TE Connectivity

Product Change Notification: P-17-014247

2mm HM connector

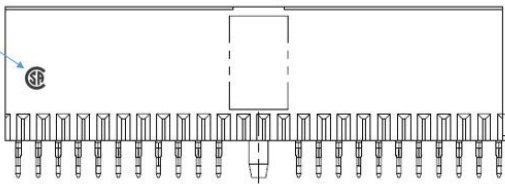
The products will be added a CSA mark on plastic.

CSA mark

CSA mark

Product improvement. 2mm HM connectors had passed CSA (Canadian Standards Association) certification since 1996, but CSA mark was not added on product. CSA request to add CSA mark on each connector.
